## PIC18F85J11 Family Silicon Errata and Data Sheet Clarification

The PIC18F85J11 family devices that you have received conform functionally to the current Device Data Sheet (DS39774D), except for the anomalies described in this document.

The following typographic corrections and clarifications are to be noted for the latest version of the device data sheet (DS39774D):

**FIGURE 2-3 FREQUENCY vs. ESR PERFORMANCE FOR SUGGESTED VCAP**

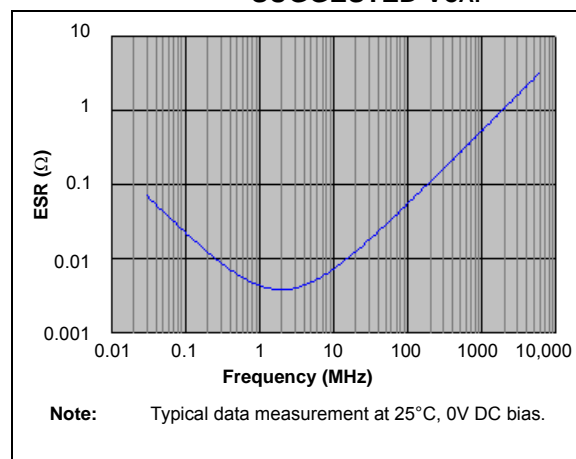
Section 2.4 “Voltage Regulator Pins (ENVREG and VCAP/VDDCORE)” has been replaced with a new and more detailed section. The entire text follows:

When the regulator is enabled, a low-ESR (< 5Ω) capacitor is required on the VCAP/VDDCORE pin to stabilize the voltage regulator output voltage. The VCAP/VDDCORE pin must not be connected to VDD and must use a capacitor of 10 μF connected to ground. The type can be ceramic or tantalum. Suitable examples of capacitors are shown in Table 2-1. Capacitors with equivalent specifications can be used.

Designers may use Figure 2-3 to evaluate ESR equivalence of candidate devices.

**FIGURE 2-4 DC BIAS VOLTAGE vs. CAPACITANCE CHARACTERISTICS**

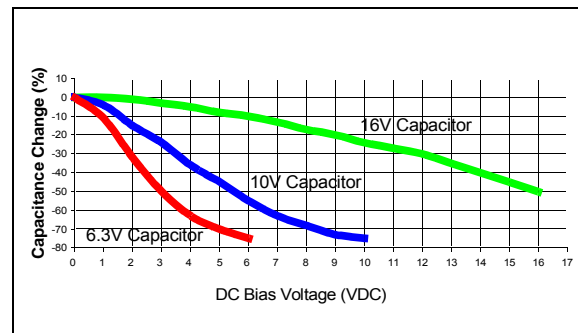
In addition to temperature tolerance, the effective capacitance of large value ceramic capacitors can vary substantially, based on the amount of DC voltage applied to the capacitor. This effect can be very significant, but is often overlooked or is not always documented.

A typical DC bias voltage vs. capacitance graph for X7R type and Y5V type capacitors is shown in Figure 2-4.

When selecting a ceramic capacitor to be used with the VDDCORE voltage regulator, it is suggested to select a high-voltage rating, so that the operating voltage is a small percentage of the maximum rated capacitor voltage. For example, choose a ceramic capacitor rated at 16V for the 2.5V VDDCORE voltage. Suggested capacitors are shown in Table 2-1.
